EXAMPLE #1

PROJECT MANAGEMENT - PUBLIC SERVICES - CITY OF ANN ARBOR	
UNIVERSITY OF MICHIGAN WILLIAM L. CLEMENTS LIBRARY INFRASTRUCTURE IMPROVEMENTS AND ADDITION UM PROJECT NUMBER: P00001692 RIGHT OF WAY GRADING PLAN	
SCALE HORIZ. 1"=20' VERT. 1"=2'	0 INCH 1
DRAWING NO.	CG1.1
SHEET NO.	OF

PRELIMINARY SITE PLAN REVIEW

UM AEC Proj No #: P00008399;

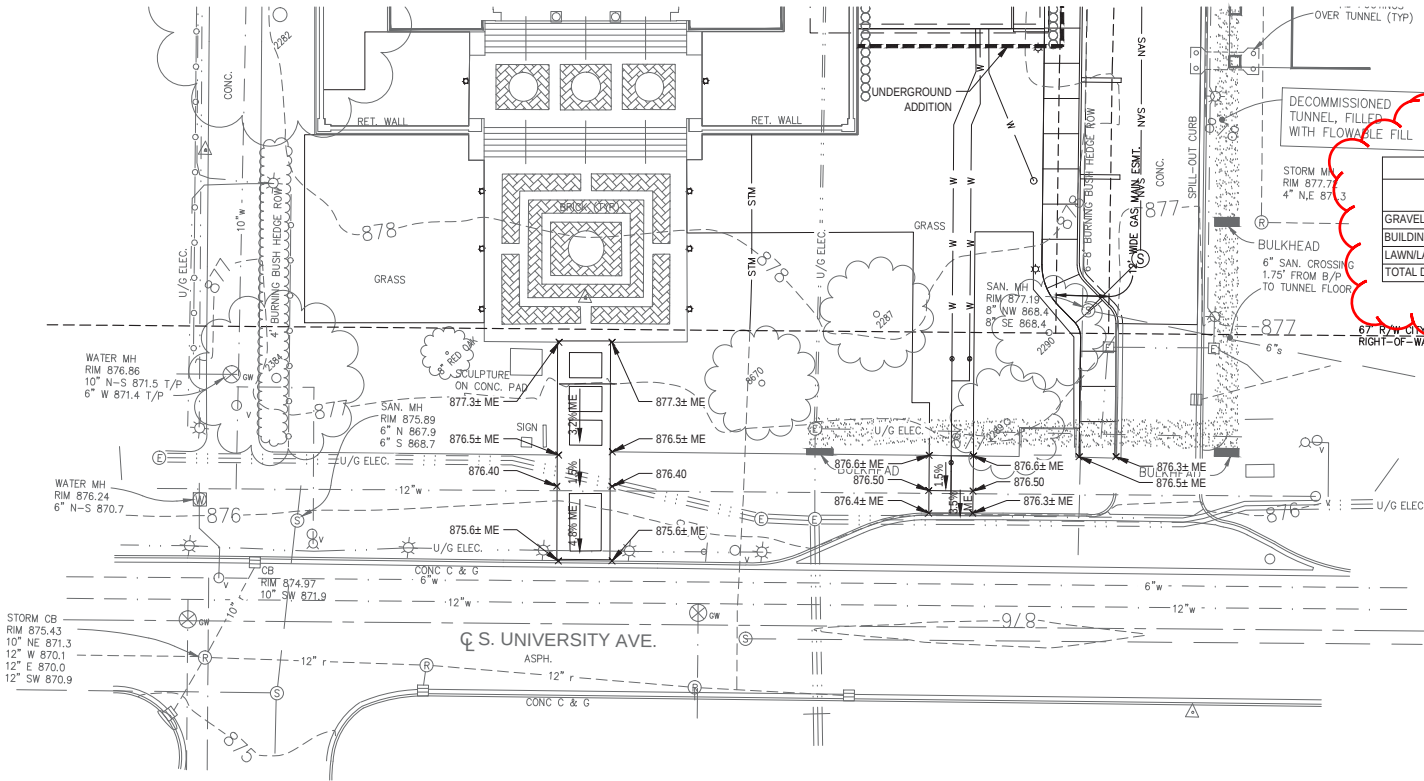
Show chart of with change in impervious -see attached example chart. Increase in impervious must be reviewed/approved by U-M Campus Planning and project team may be directed to design additional storm water management BMPs.

Provide a list of elective storm water BMP's to be installed and quantify benefits, if feasible.

Include the language: "Construction and operation of the storm water (infiltration/detention pond) or (BMP's on the plans) is/are in compliance with the requirements of State and Federal water pollution control laws."

Replace chart with format matching example chart below

UM AEC : T-1C

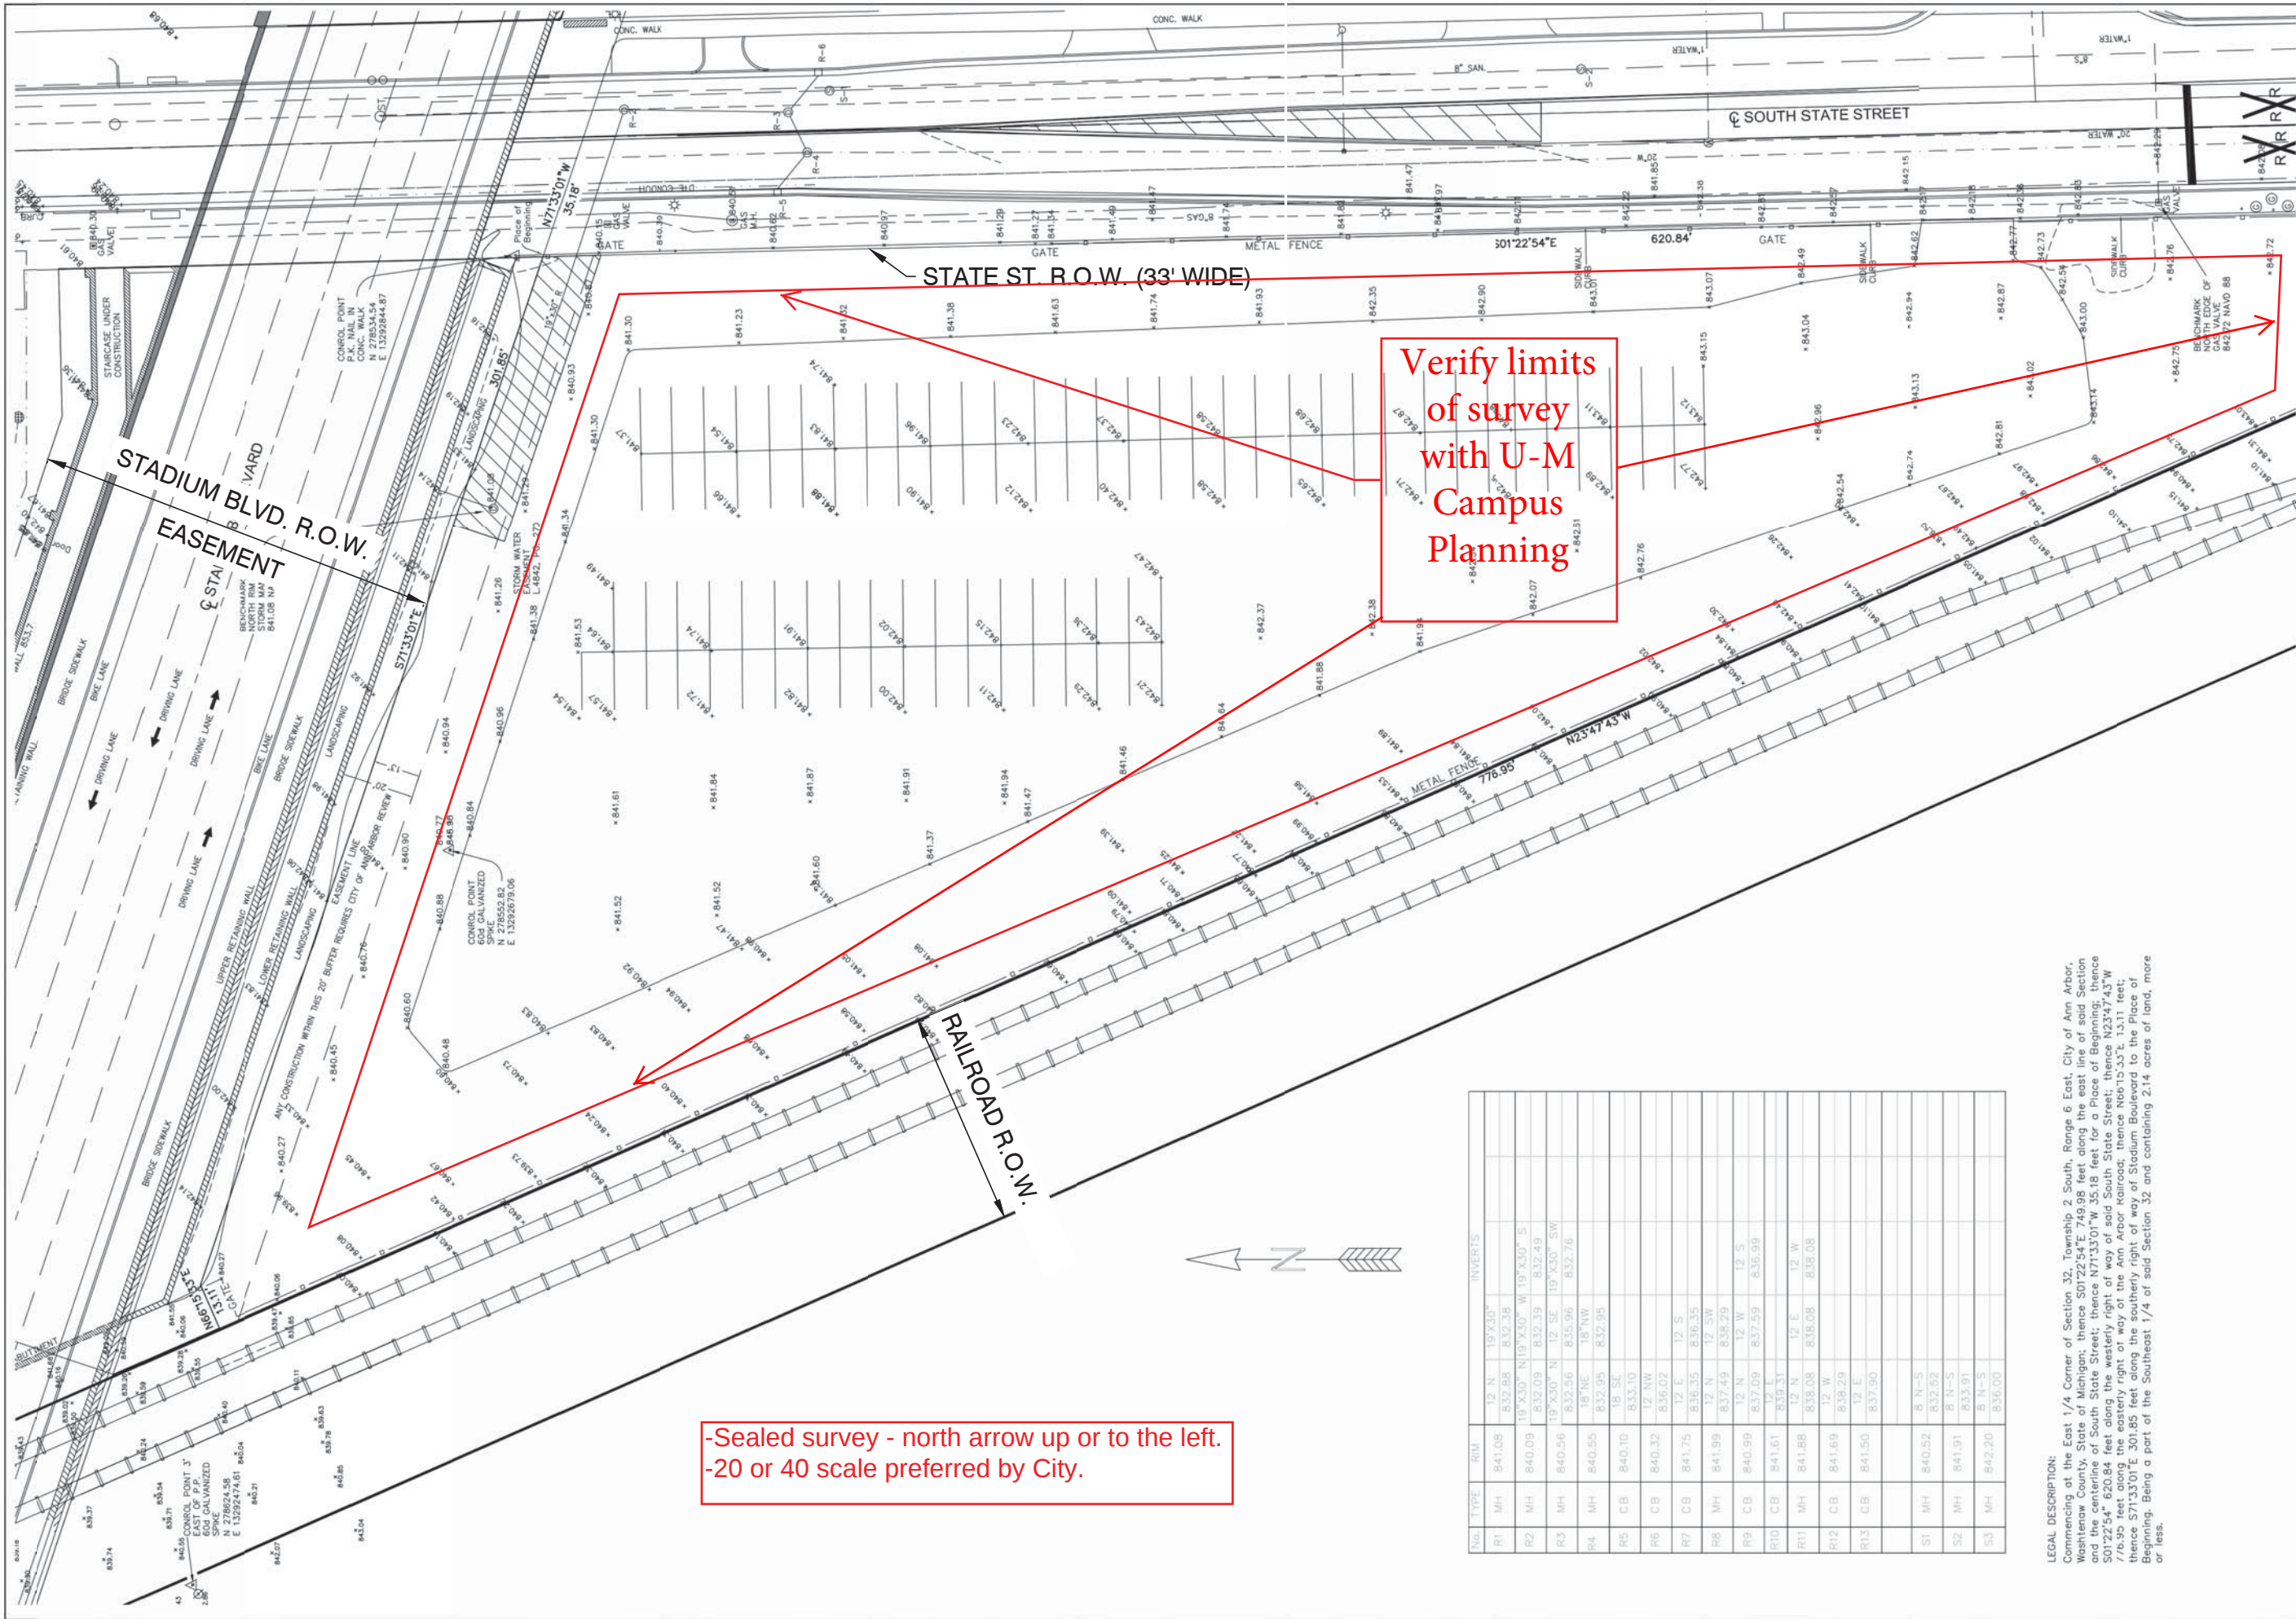
For City projects only - Title Sheet Listing type of City Review

-Sealed survey - north arrow up or to the left.
-20 or 40 scale preferred by City.

C104C

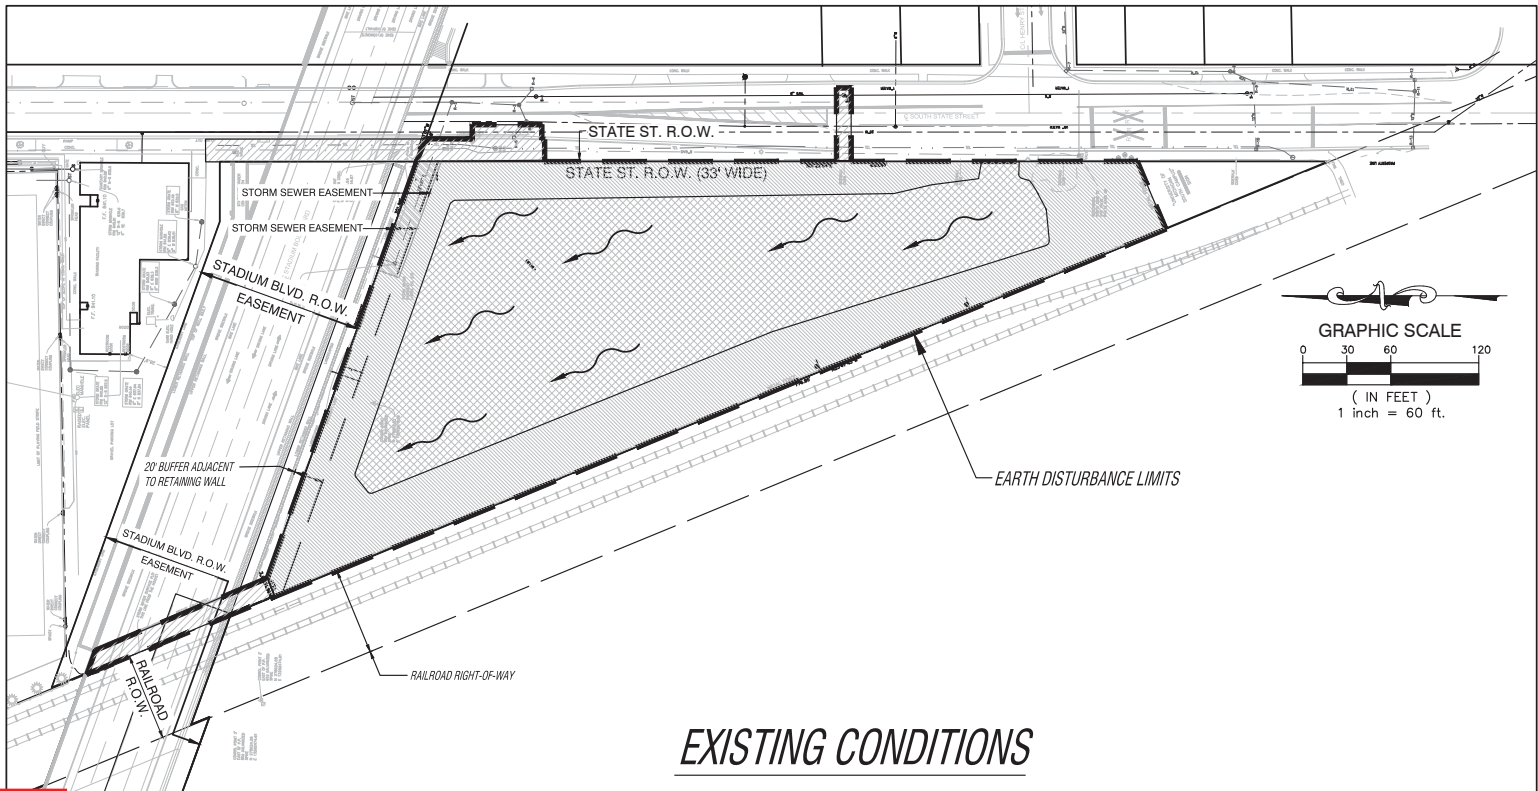
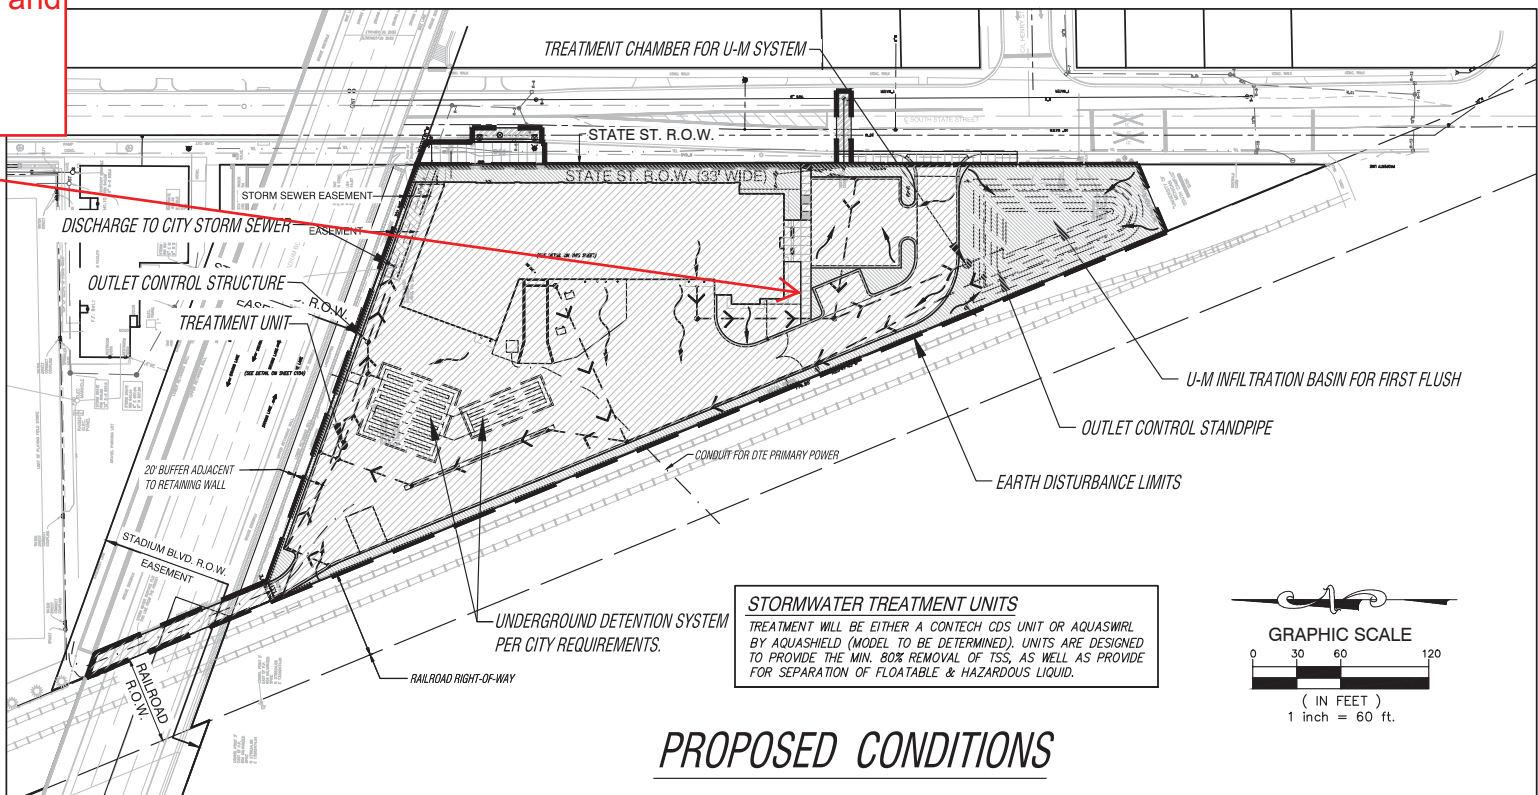
- Storm water sheet.
- Show drainage patterns of proposed and existing conditions with different hatching based on imperviousness. (See Campus Planning level of detail provided on U-M property)
- Provide narrative summarizing storm water as noted below.

Storm water narrative

C104AC

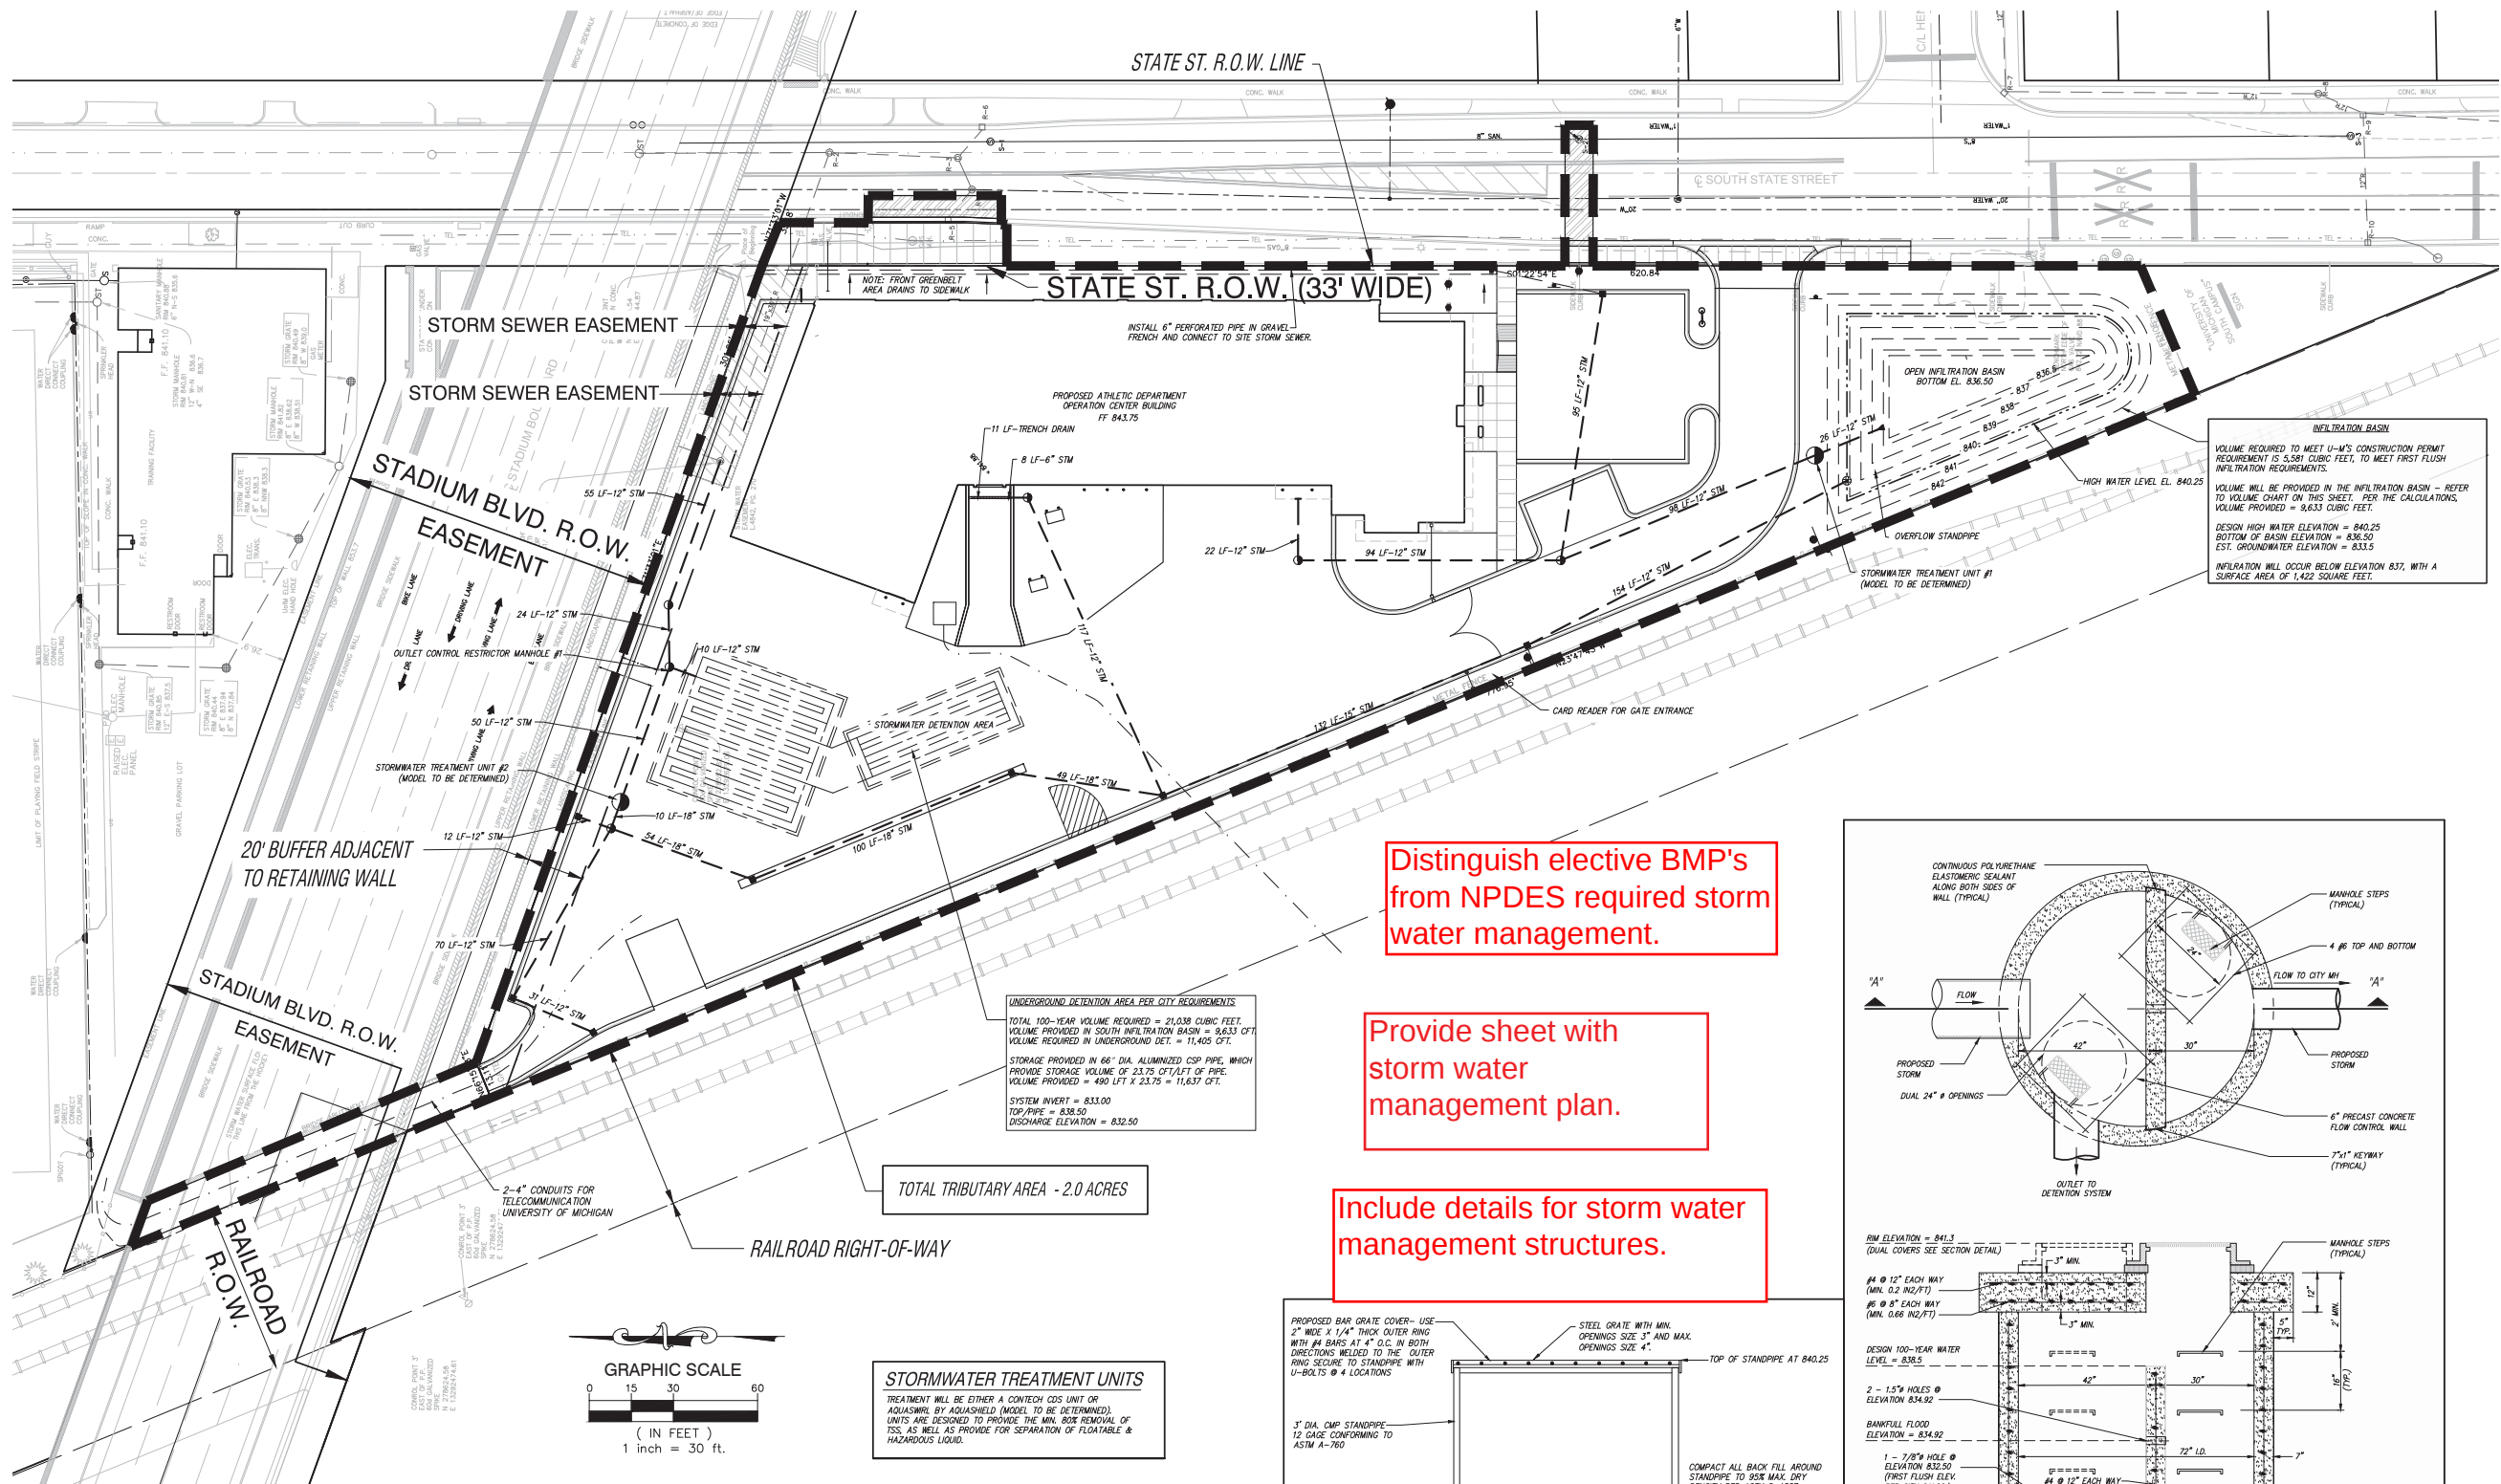
Distinguish elective BMP's from NPDES required storm water management.

Provide sheet with storm water management plan.

Include details for storm water management structures.
